17-37 WILLIAM ROAD | LONDON

SECTION 96A APPLICATION: DESIGN & ACCESS STATEMENT

24158-56T-P8-XXX-R-A-001-P04
05.02.2025

A / Proposed Basement Plan

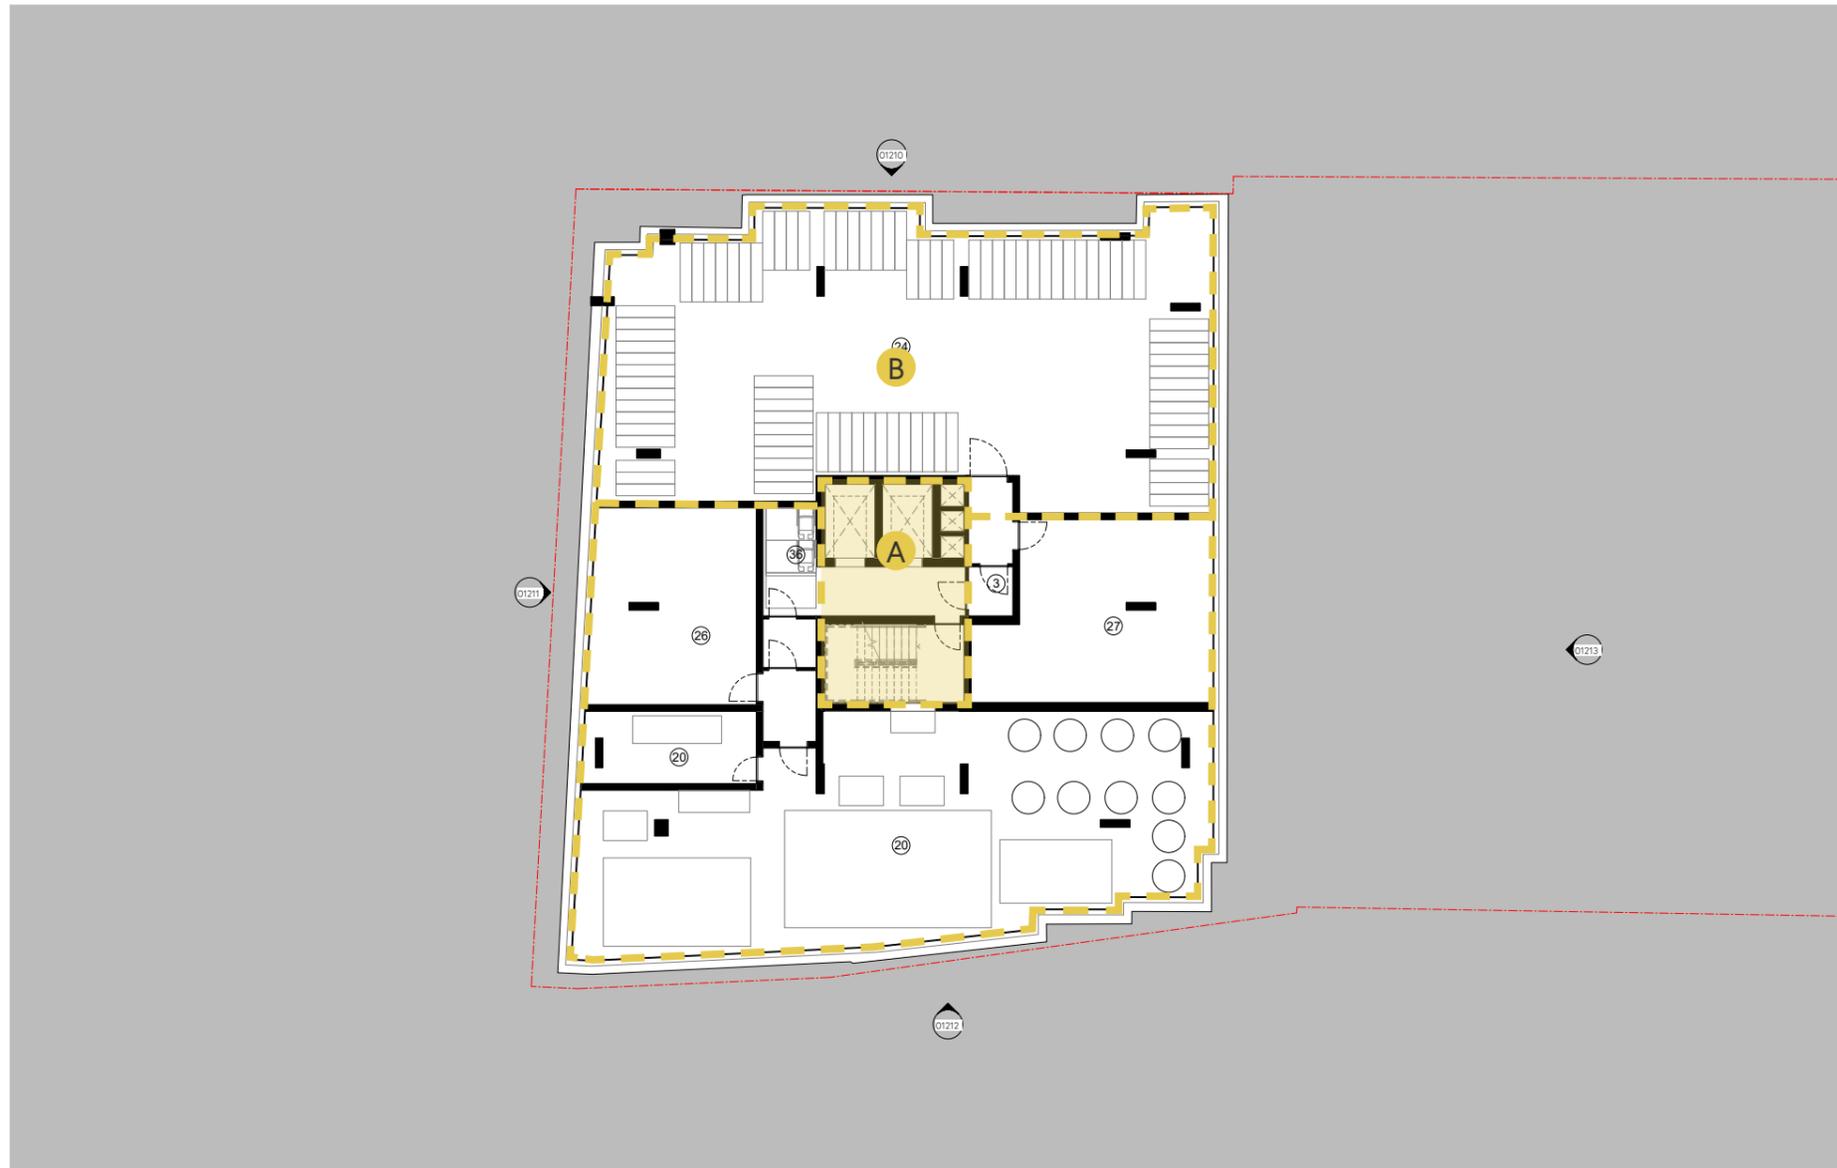
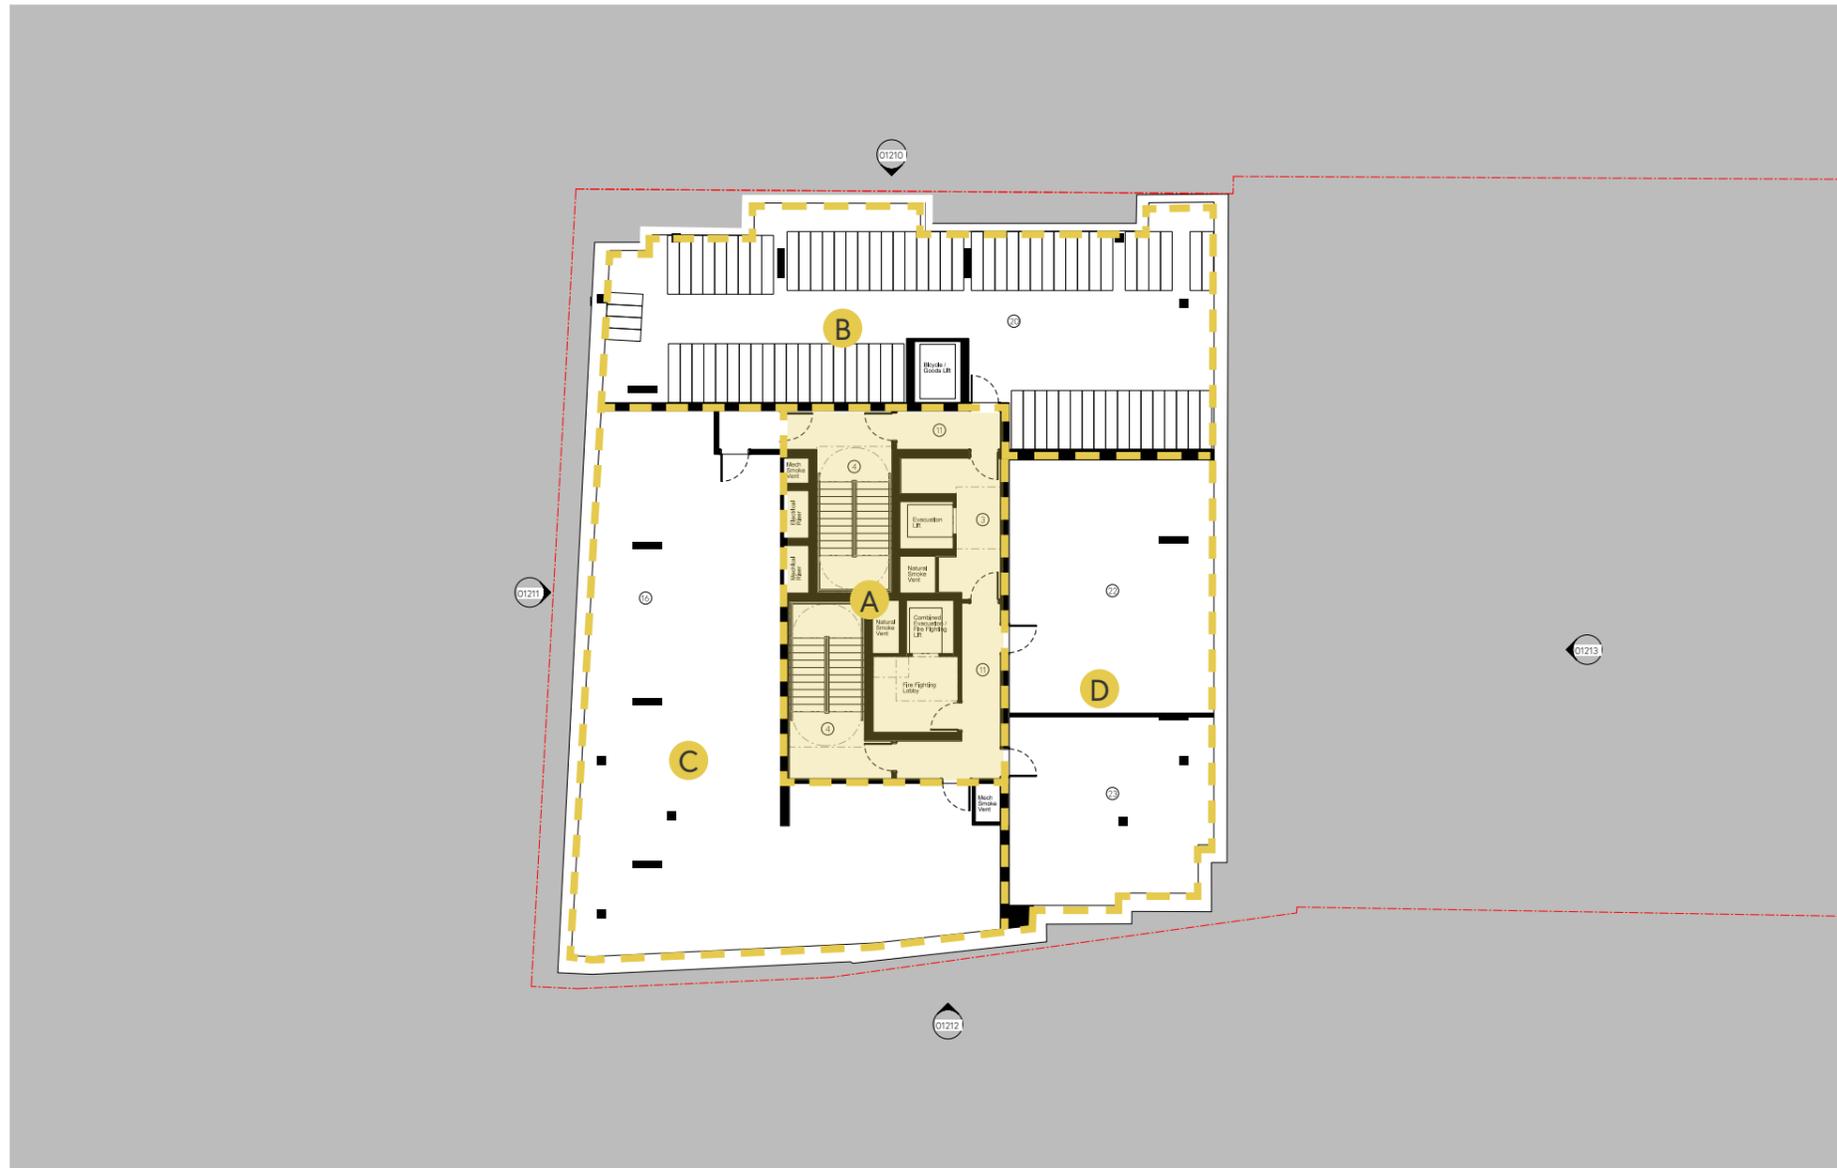
- A. Circulation core requires amendment to suit updated fire safety principles
- B. Long-stay cycle storage has limited access facilities with only the building's passenger lift not suitable for pedal bikes.

- A. Circulation core updated to suit fire safety principles
- B. Cycle store resized to suit new bedspace numbers at 0.75 spaces per bedroom for long-stay cycle parking. The cycle store is now provided with a dedicated goods lift to facilitate and encourage easy access.
- C. Resized plant room to accommodate MEP designed building services strategy
- D. Amenity relocated together to facilitate more cohesive and associated uses with potential to bring in natural light from the above courtyard.

A / Proposed Level 04-05 Floor Plan

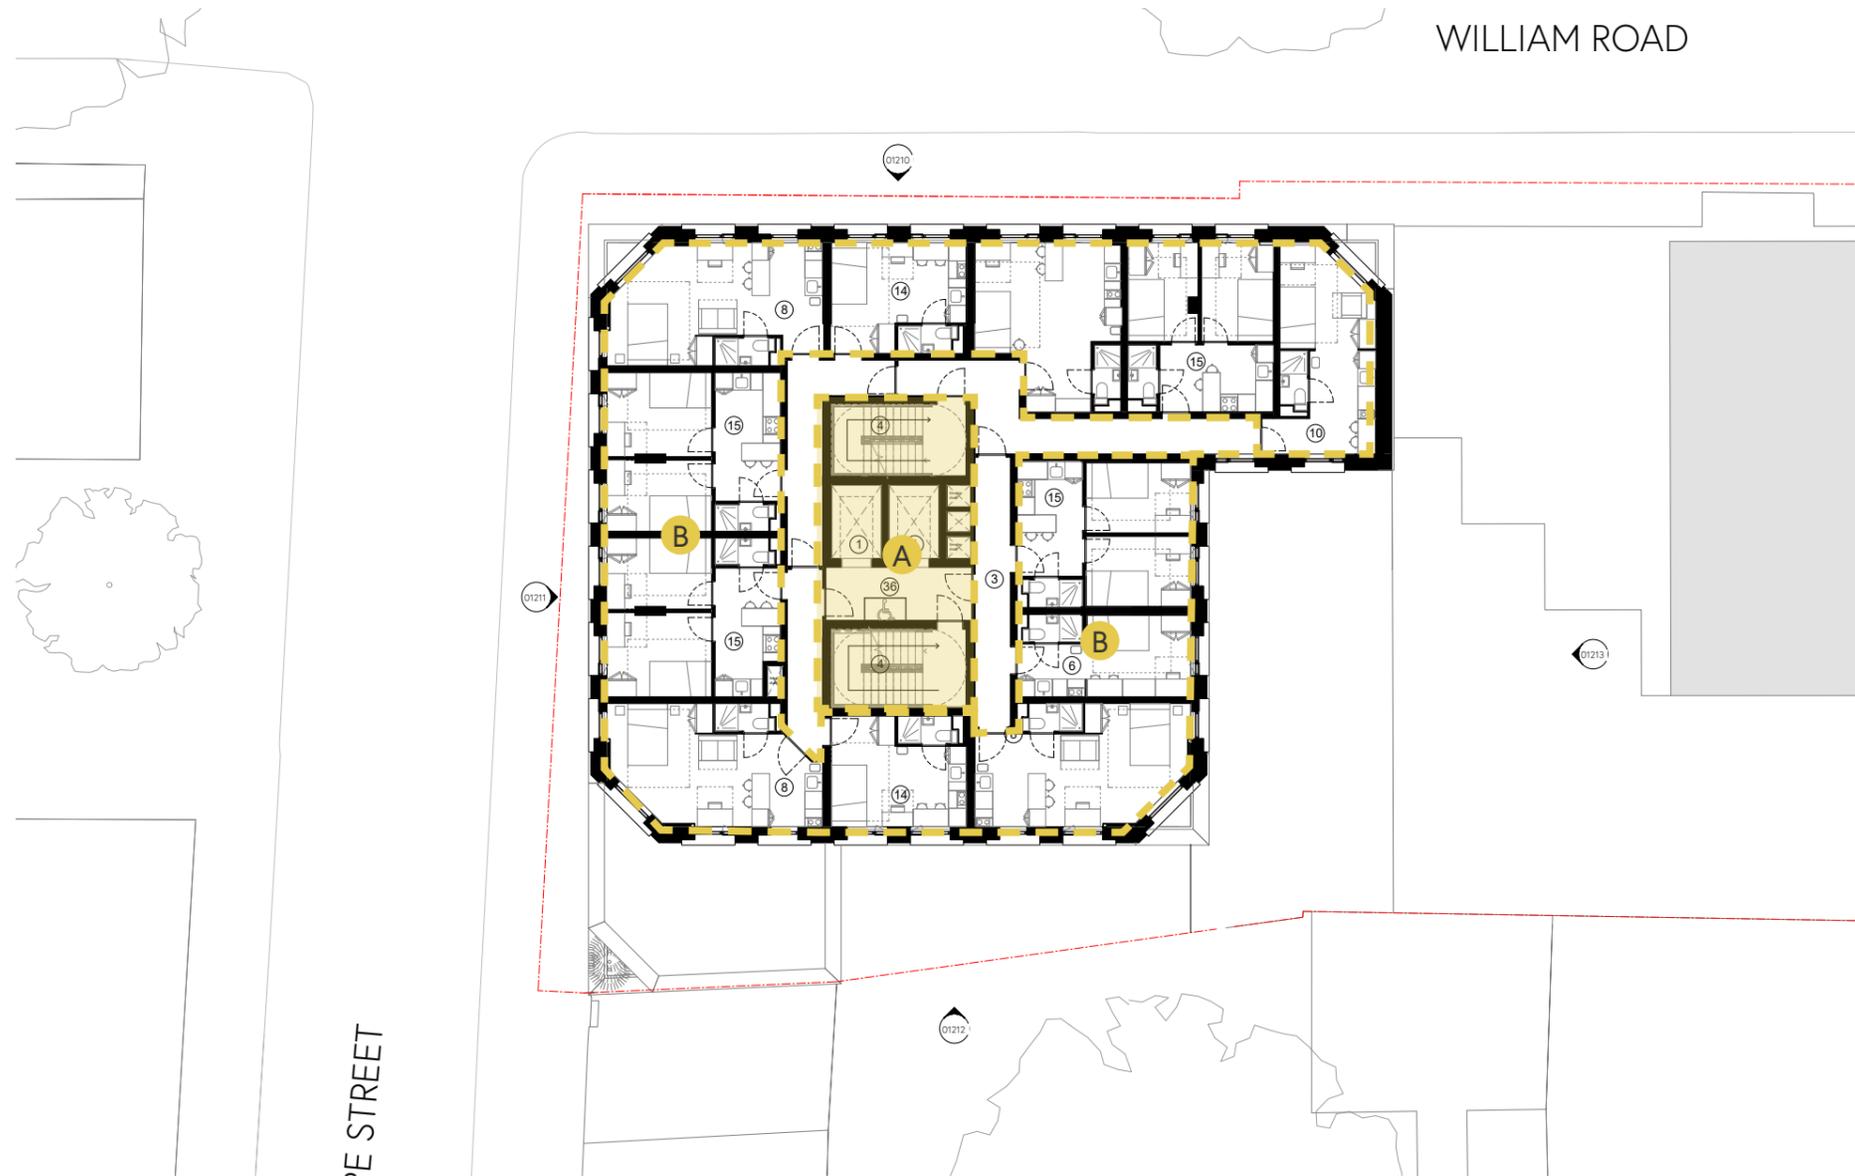
- A. Circulation core updated to suit fire safety principles
- B. Accommodation layout and types adjusted generally to suit fire safety principles

A / Proposed Level 06-07 Floor Plan

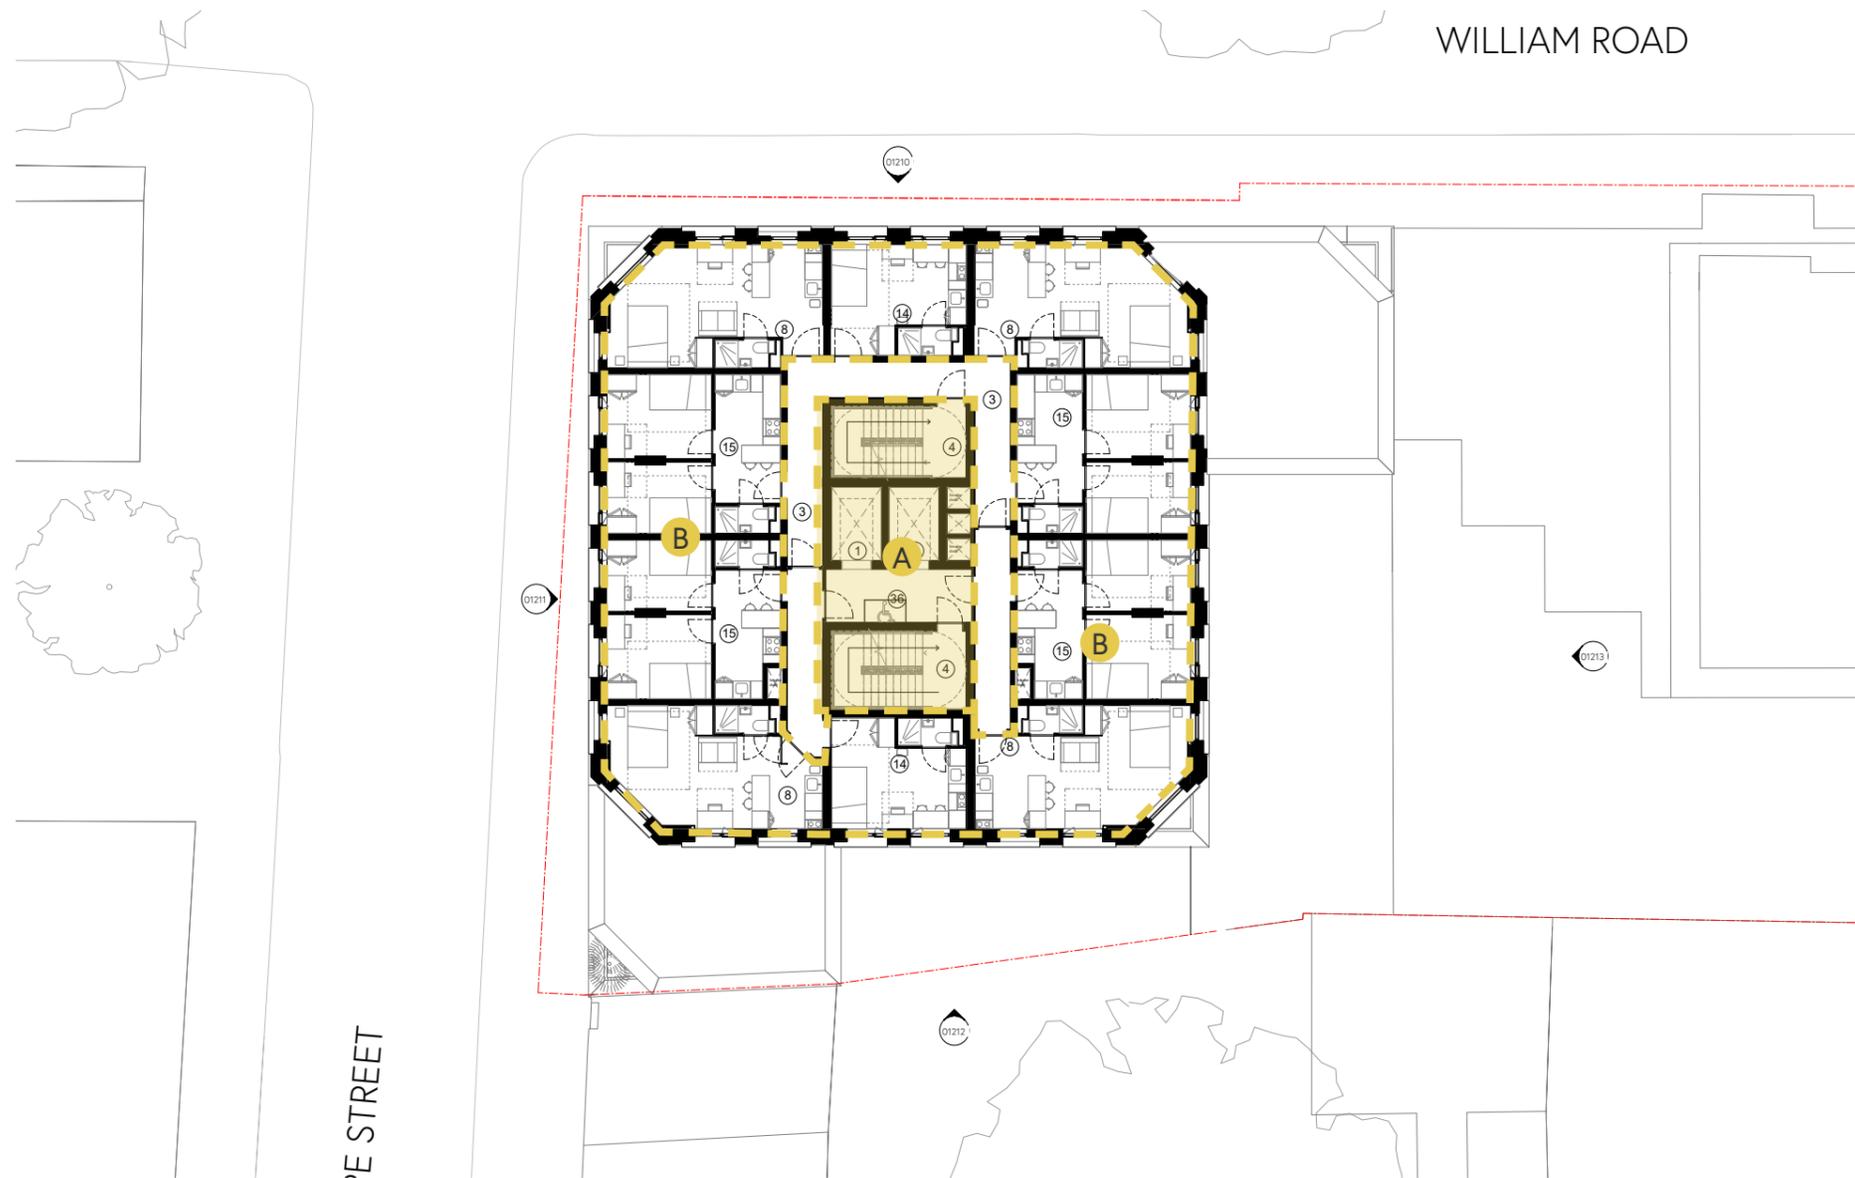
- A. Circulation core updated to suit fire safety principles
- B. Accommodation layout and types adjusted generally to suit fire safety principles

A / Proposed Level 14 Floor Plan

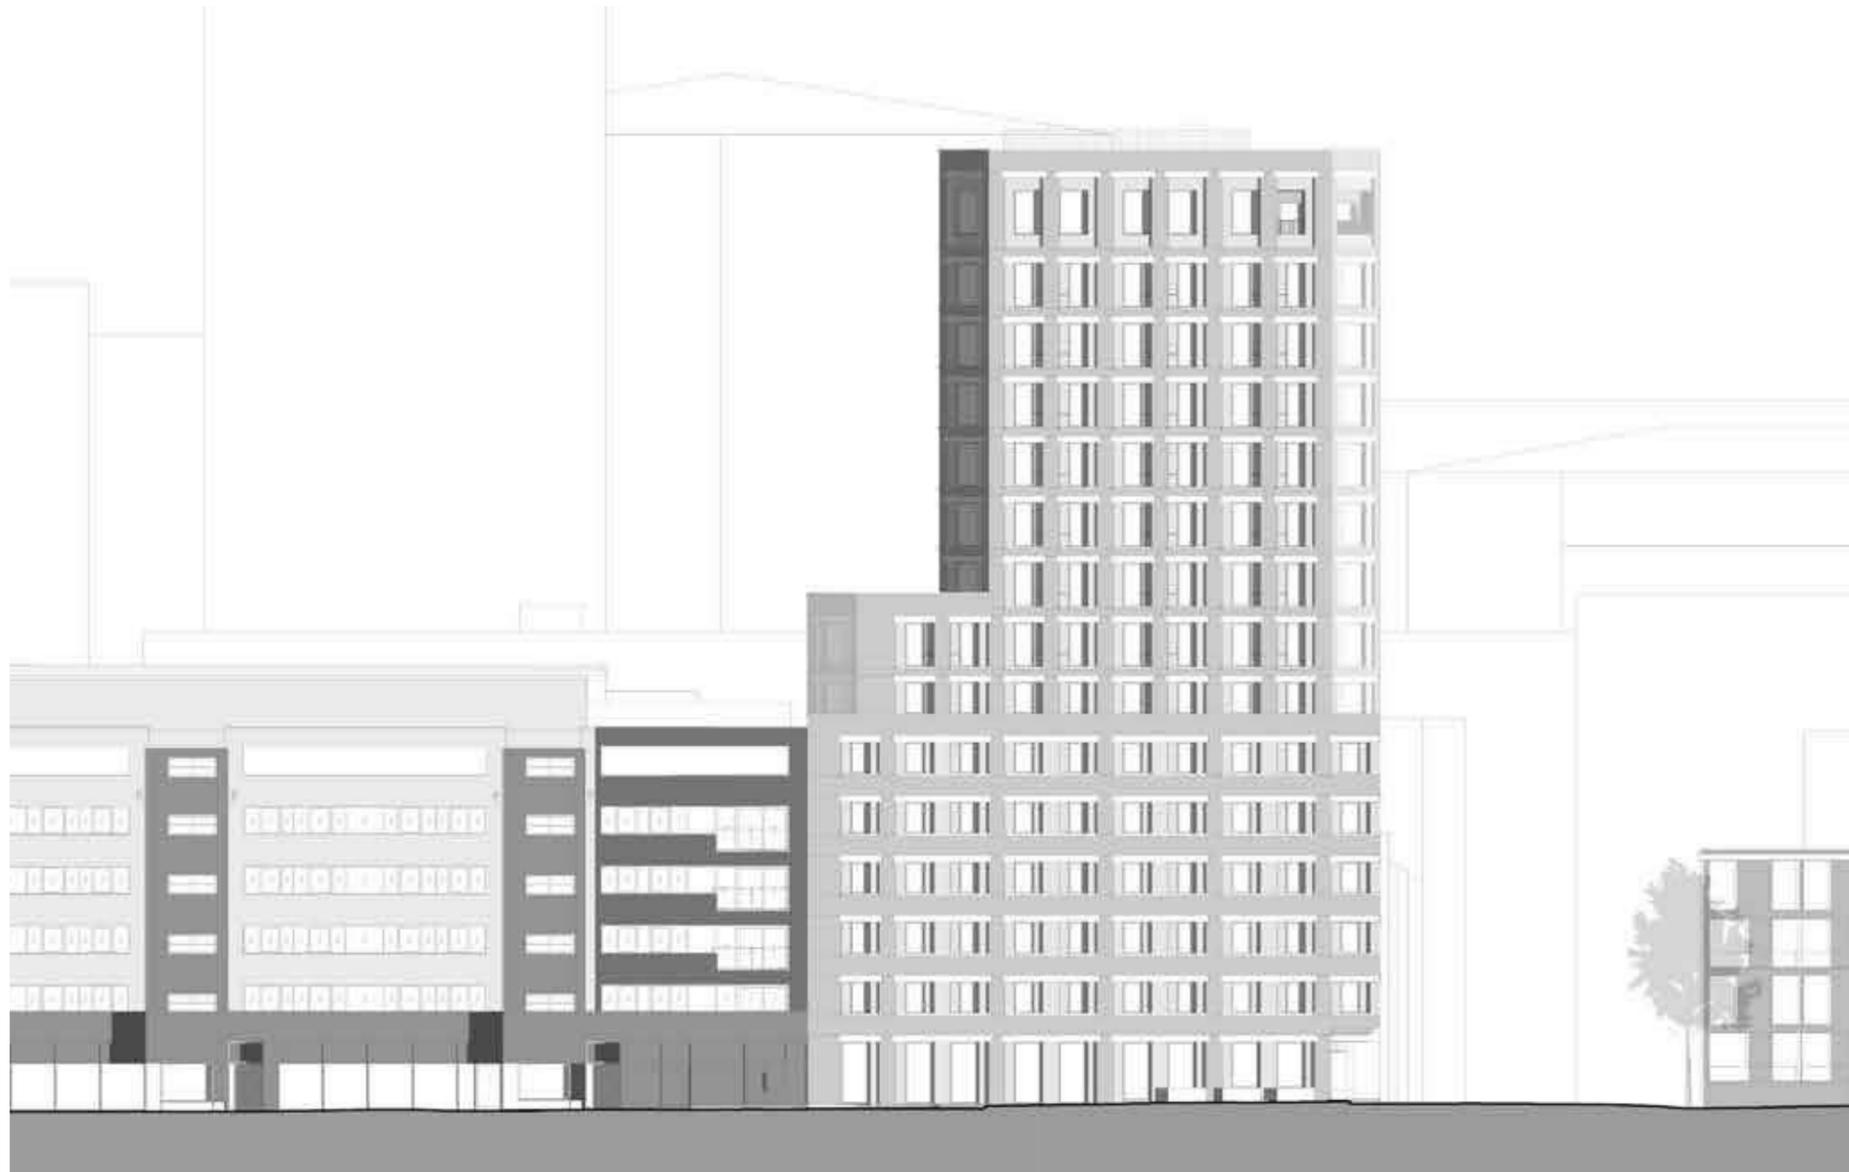
- A. Circulation core updated to suit fire safety principles
- B. Additional accommodation provided at 14th Floor to offset additional amenity at Ground Floor and Basement
- C. Retained amenity addressing external loggia and terrace
